IREDELL COUNTY HEALTH DEPARTMENT

IMPROVEMENT PERMIT / CERTIFICATE OF COMPLETION / OPERATION PERMIT / EXISTING SYSTEM INSPECTION

PROPERTY DESCRIPTION NO. 16849 DATE 8-26-93 TAX MAP NO. 106 A 4C

AS BUILT SKETCH

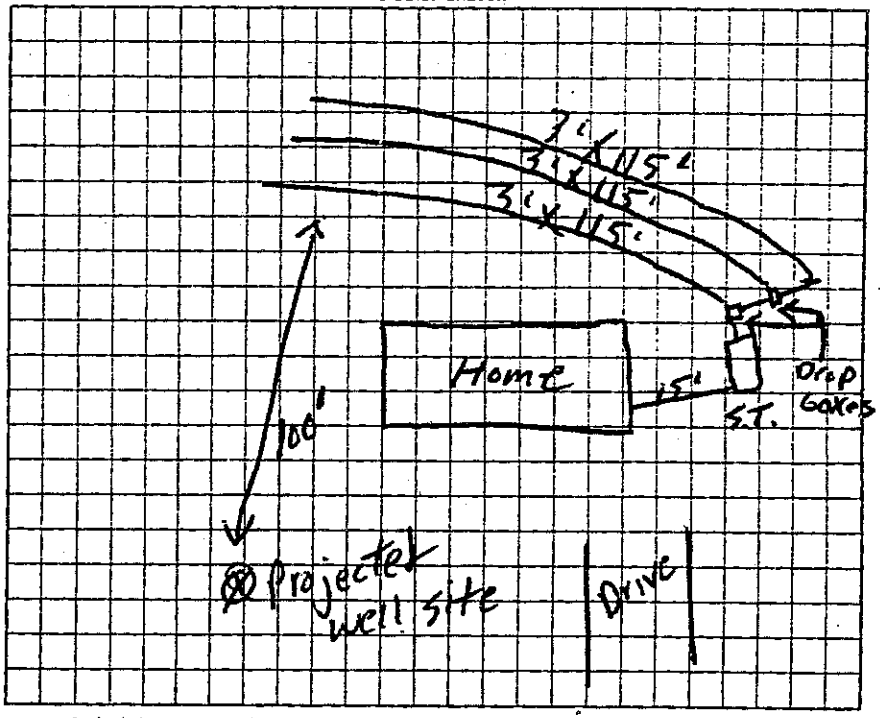
The location of the proposed GARAGE (22' X 26') addition does not appear to impact the existing septic system.

**NOTE: KEEP GARAGE MINIMUM 5' FROM SYSTEM
